**SUBJECT:** **NEW VEHICLE DEMONSTRATION / DELIVERY HOLD - Safety Recall 17S33 - Supplement #2**  
 Certain 2015-2017 Model Year F-150 and 2017 Model Year F-Super Duty Vehicles  
 Doors Will Not Close or Open While Driving

**New! REASON FOR THIS SUPPLEMENT**

*Technical Information: Updated to include lubricating certain door latch and door cable components and modifying the door lock rod grommets. As a result, the Labor Allowances, Claims Preparation and Submission and Parts Requirements / Ordering Information have also been updated accordingly.*

**FIGURE 9**

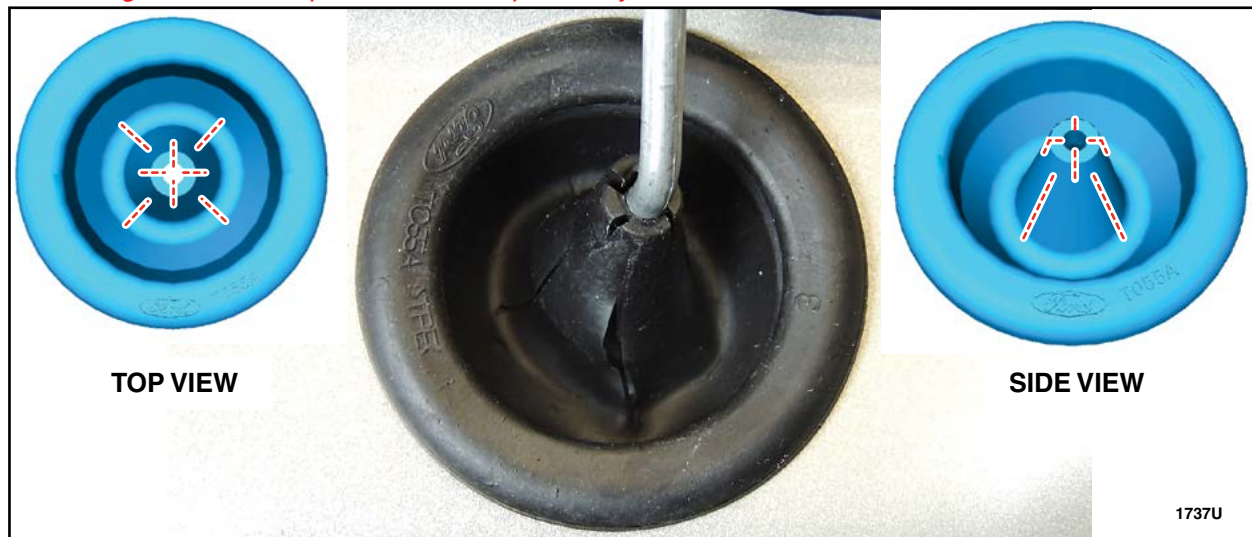
14. Modify the front door Lock Rod Grommet. See Figure 9.

- a. Using a utility knife, cut four 6 mm (.25 in) long slits approximately 90° apart into the top of the front door lock rod grommet where the lock rod exits the grommet.
- b. Cut four additional 13 mm (.5 in) long slits approximately 90° apart on the inner sides of the grommet 45° separated from the previously cut slits.

**FIGURE 11**

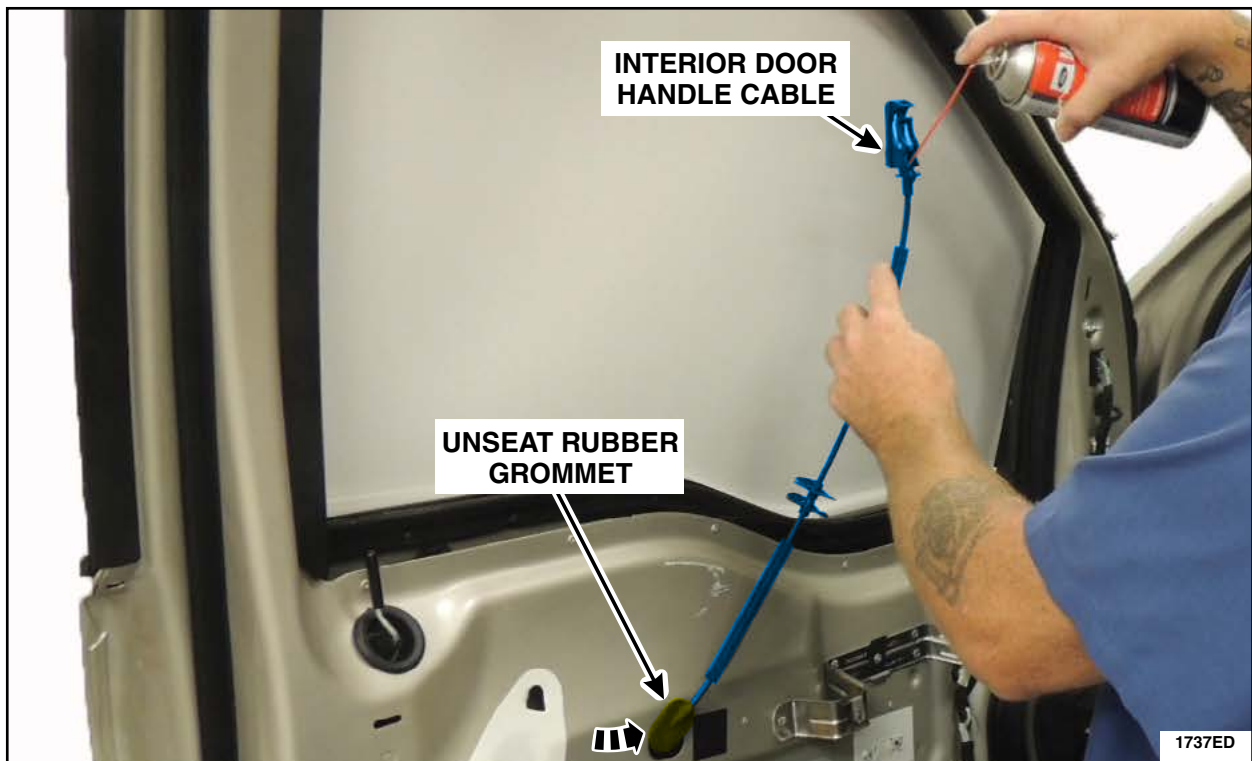
17. Unseat the interior door handle cable rubber grommet and while holding the end of the cable in an upward position, spray Motorcraft® XL-6 silicone lubricant down into the cable for five seconds. See Figure 11.

**FIGURE 13a**

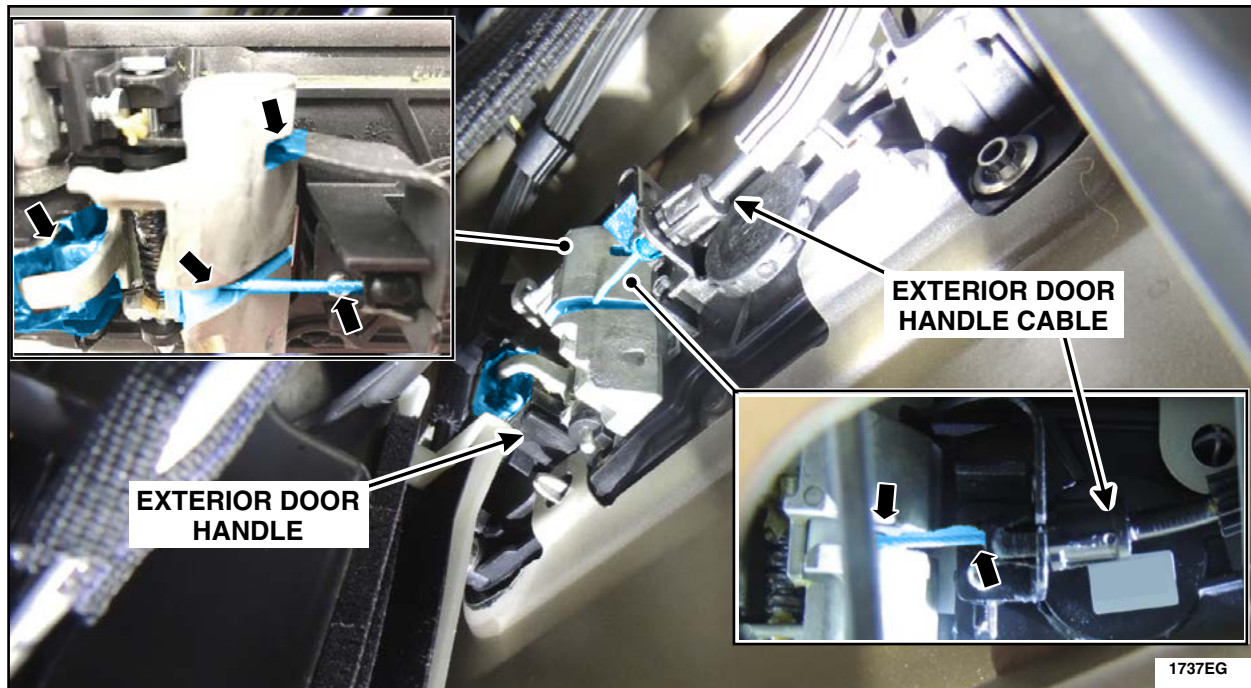
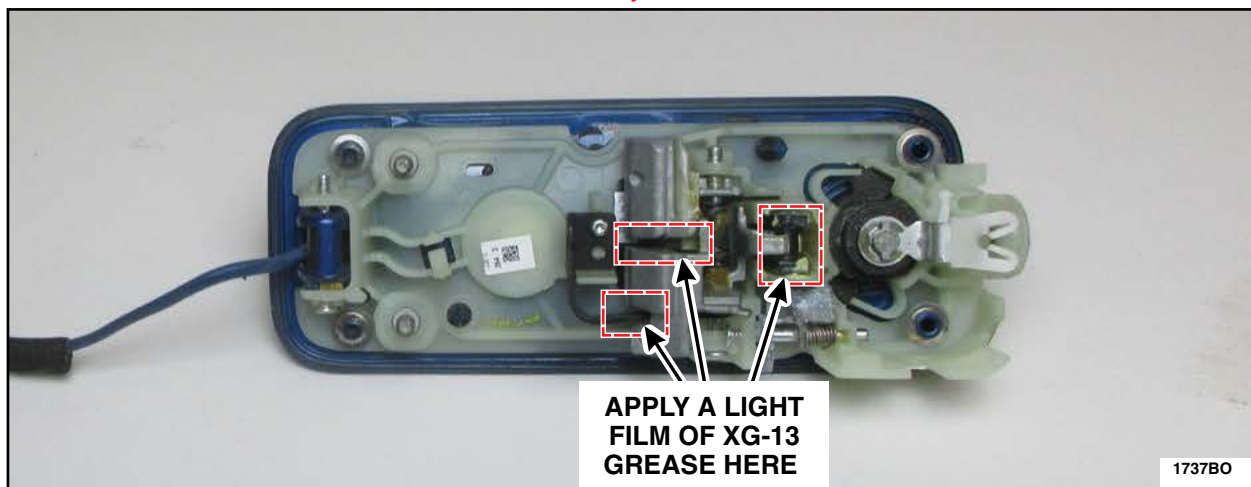
19. Through the large door sheet metal opening, use a brush to apply a light film of Motorcraft® XG-13 door latch grease to the exterior door handle cable end, and to the three additional highlighted areas. See Figures 13a and 13b.

**FIGURE 14**

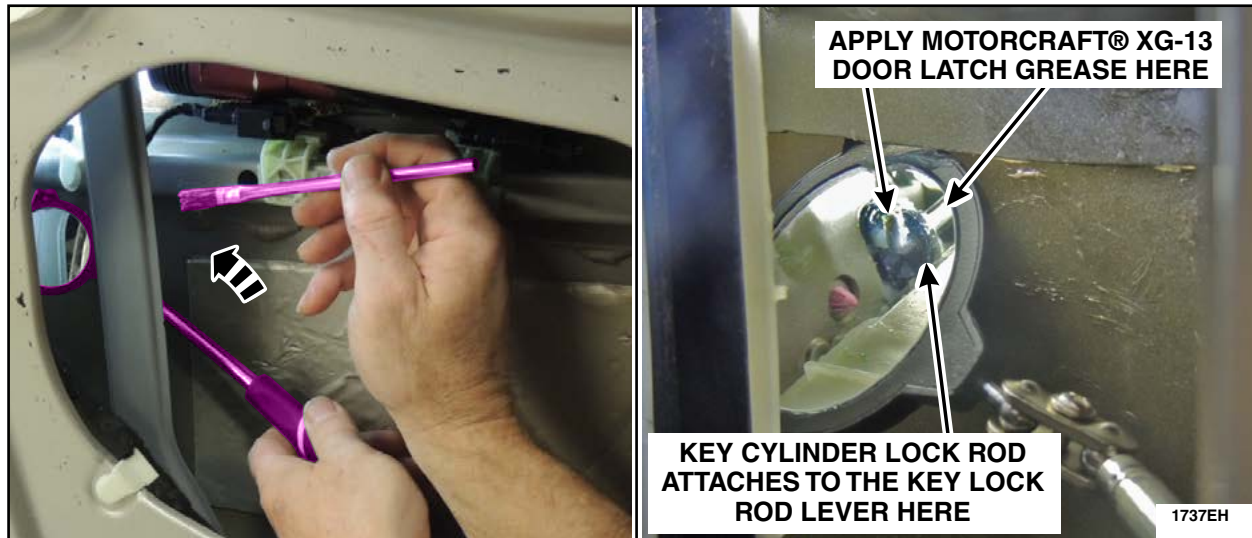
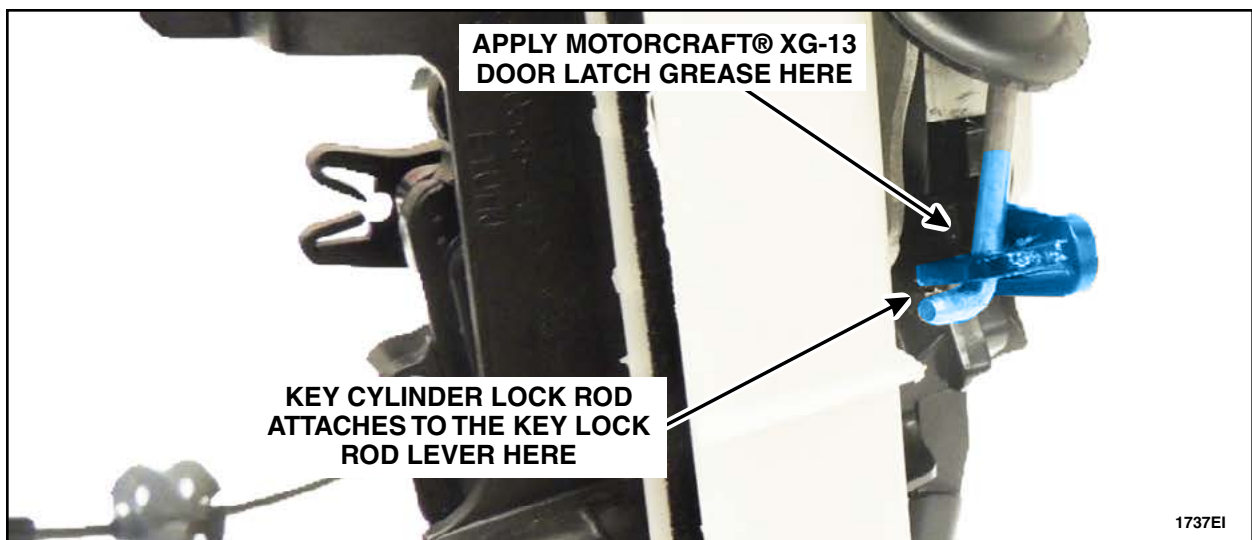
20. For driver side only, use an inspection mirror to locate and liberally apply Motorcraft® XG-13 door latch grease to the area where the key cylinder lock rod attaches to the key lock rod lever.  
See Figures 14 and 15.

**FIGURE 23**

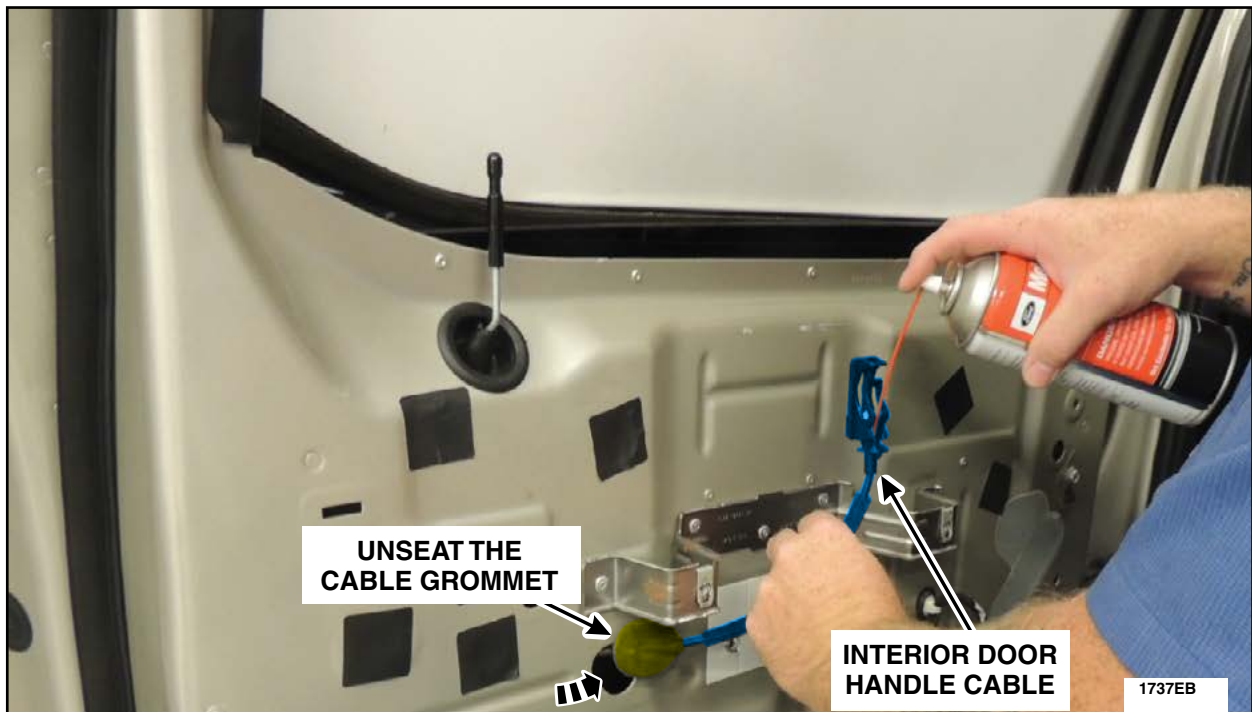
11. Unseat the interior door handle cable rubber grommet and while holding the end of the interior door handle cable in an upward position, spray Motorcraft® XL-6 silicone lubricant for five seconds down into the cable. See Figure 23.

**FIGURE 25a**

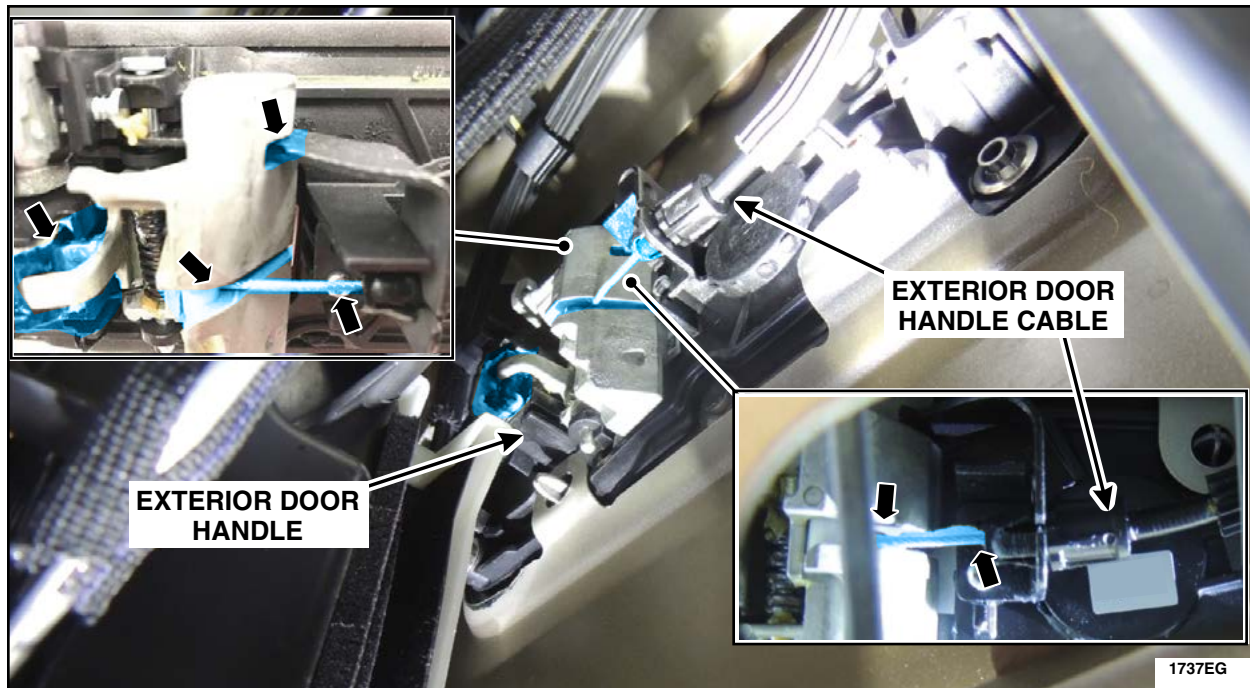
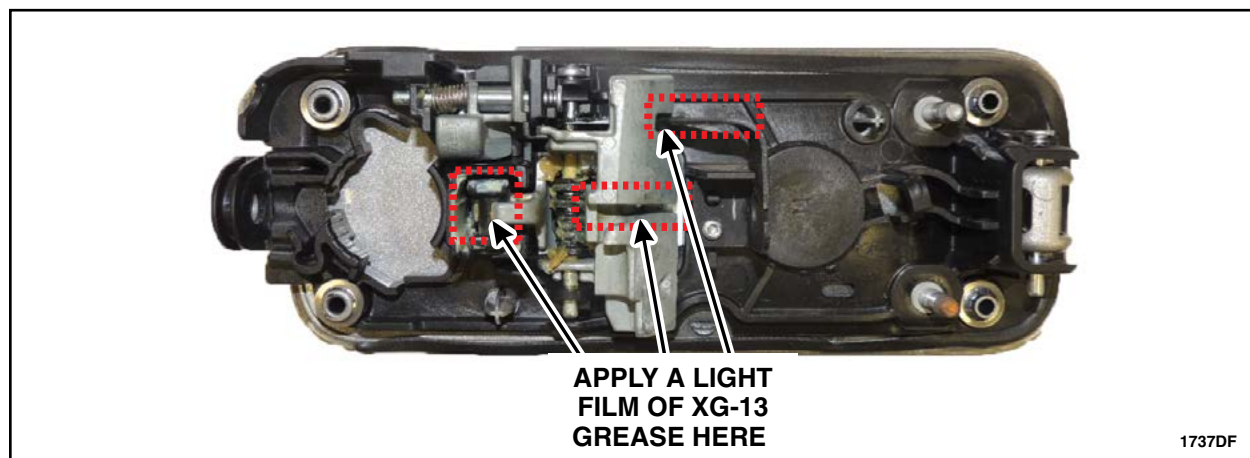
13. Through the large door sheet metal opening, use a brush to apply a light film of Motorcraft® XG-13 door latch grease to the exterior door handle cable end, and to the three additional highlighted areas. See Figures 25a and 25b.
